# Access Compliance Report

## Public Rights-of-Way

### (Curb Ramps)

Intersection ID: 11707	Main Street: N_GRAHAM_ST	Cross Street: W_6TH_ST	Location: S
ADA ID: B3705683E6B6	Ramp Type: PerpDiag	Initial Pass/Fail: Fail	Overall Compliance: No
Severity Score: 25			
Codes/Mitigation Info/Possible Solution		Field Measurements/Component Compliance

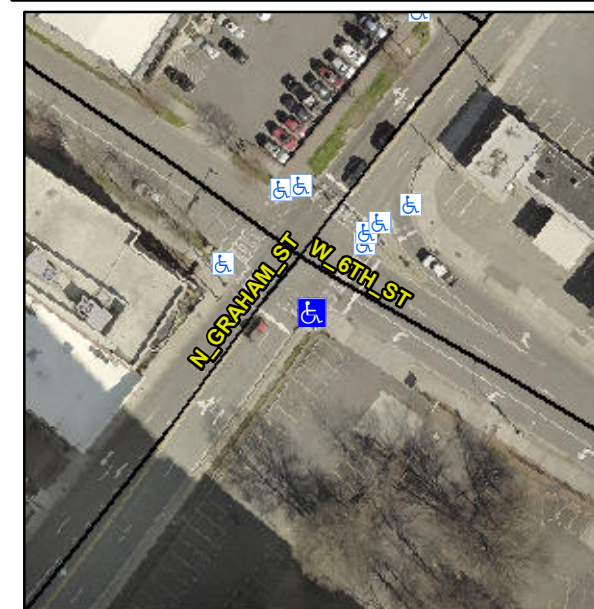
**Not Found, R304.2.2, R304.5.3**

Compliance	Description	Data	Compliance	Description	Data
N/A	Ramp Length (in)	91.0	No	Ramp Slope (%)	9.4
Yes	Ramp Width (in)	115.0	No	Ramp XSlope (%)	5.1
N/A	Flare Type LT	N/A	N/A	Flare Type RT	N/A
N/A	Flare Slope LT (%)	N/A	N/A	Flare Slope RT (%)	N/A
N/A	Flare Traversable LT?	N/A	N/A	Flare Traversable RT?	N/A
N/A	Landing Length (in)	N/A	N/A	DWS Provided?	N/A
N/A	Landing Width (in)	N/A	N/A	DWS Contrast?	N/A
N/A	Landing Slope (%)	N/A	N/A	DWS Length (in)	N/A
N/A	Landing X Slope (%)	N/A	N/A	DWS Full Width?	N/A
N/A	Landing Curb? (Y/N)	N/A	N/A	DWS Offset (in)	N/A
N/A	Shared Landing?	N/A			
N/A	Gutter Ponding?	N/A	N/A	Gutter Slope (%)	N/A
N/A	Gutter Lip Ht (in)	N/A	N/A	Gutter X Slope (%)	N/A
N/A	Painted X Walk1?	Yes	N/A	Painted X Walk2?	Yes
	X Walk 1 Direction	To NE		X Walk 2 Direction	To NW
N/A	X Walk 1 Width (in)	80.0	N/A	X Walk 2 Width (in)	110.0
	X Walk 1 Slope (%)	0.8		X Walk 2 Slope (%)	4.2
	X Walk 1 X Slope (%)	2.8		X Walk 2 X Slope (%)	1.1

**Remove & Replace Curb Ramp With Two New Directional Ramps or Equivalent.**
